**STATE OF VERMONT
GREEN MOUNTAIN CARE BOARD**

In re: Wake Robin Proposed Corp. Proposed)
Renovation of Skilled) Docket No. GMCB – 024-15con
Nursing Facility and Addition of)
Six Rooms)

RE: Docket No. GMCB-024-15con, Proposed Renovation of Skilled Nursing Facility and Addition of Six Rooms, Project Cost: \$8,170,130

A-3(a)

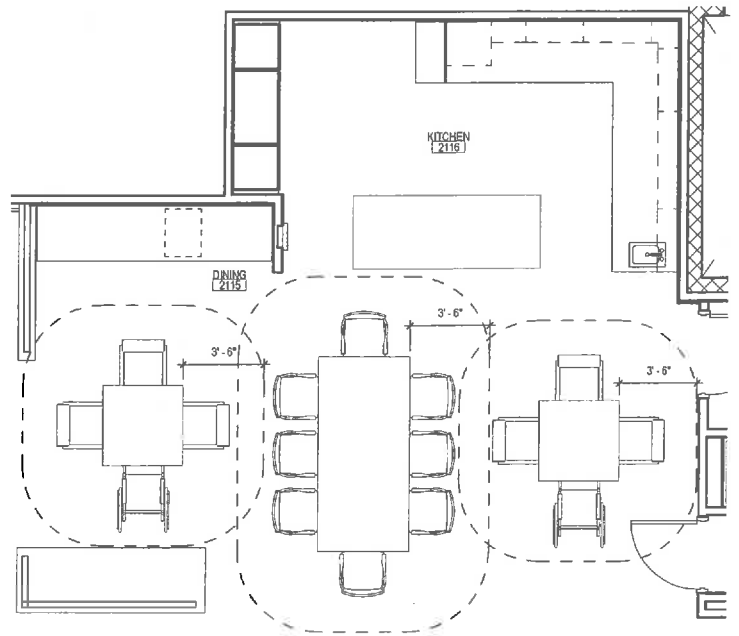
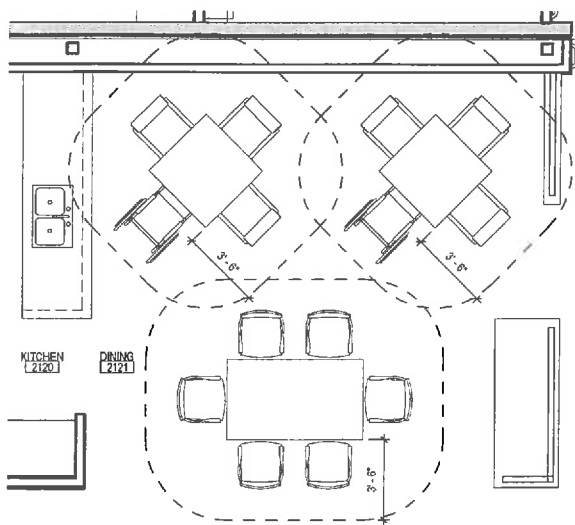
FGI Section & Requirement: FGI Guide (2014) 2.3-2.3.3.2 – Dining Areas need to provide access to leave tables without disturbing participants and space for caregivers to assist residents and participants who cannot feed themselves.

Comment: Confirm there is a clear path through new construction and newly renovated areas to dining areas.

Response: Please see attached floor plans (sheets A-3(a), A-3(b)) for clear paths at new construction and newly renovated dining areas.

A-4(a)

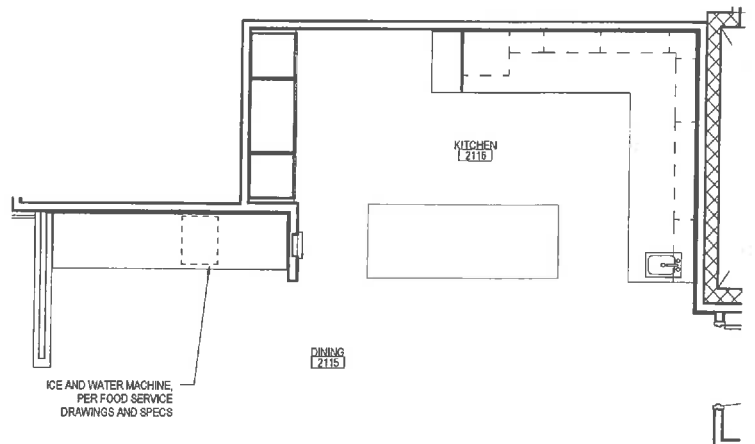
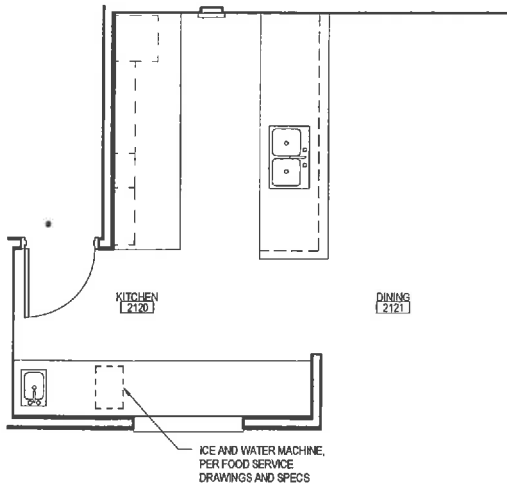
FGI Section & Requirement: FGI Guide (2014) 2.3-2.3.4.2 – Kitchen Requirements Ice Machine

Comment: Confirm the locations of the ice machines in new construction and renovated kitchen/dining areas.

Response: Please see attached floor plans (sheets A-4(a), A-4(b)) for locations of ice machines in new construction and renovated kitchen/dining areas.

A-8(a)

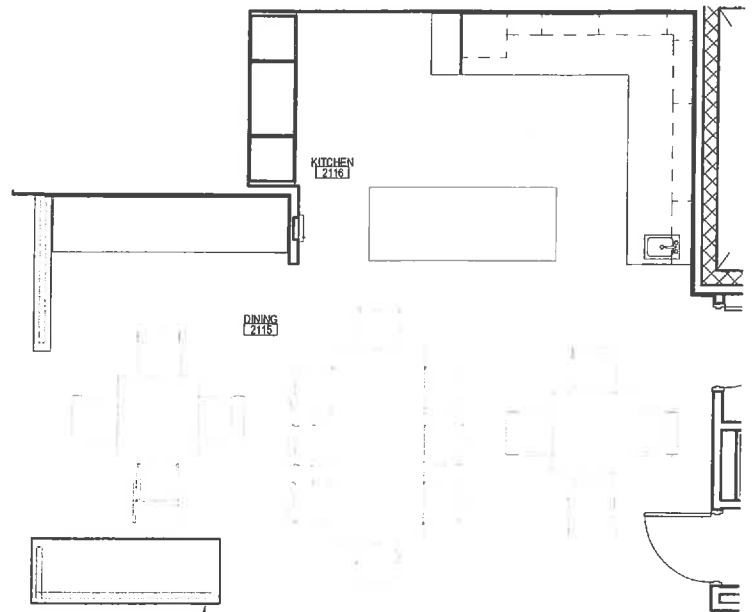
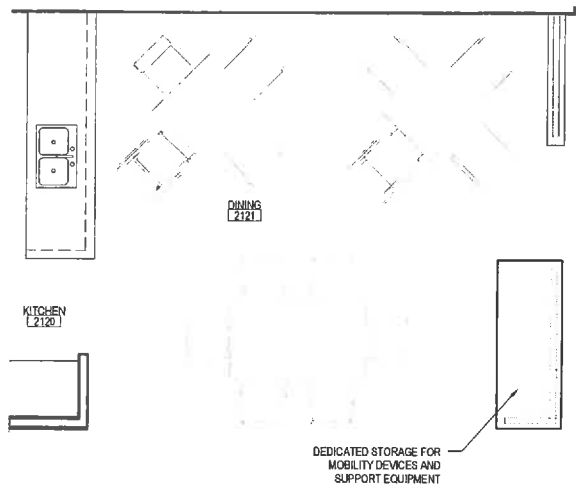
FGI Section & Requirement: FGI Guide (2014) 2.3-4.2.4.2, 3.1 – 4.2.4.3 – Requires mobile storage for resident equipment

Comment: Explain where the mobile storage is on the plans.

Response: Please see attached floor plans (sheets A-8(a), A-8(b)) for locations of mobility devices and support equipment.
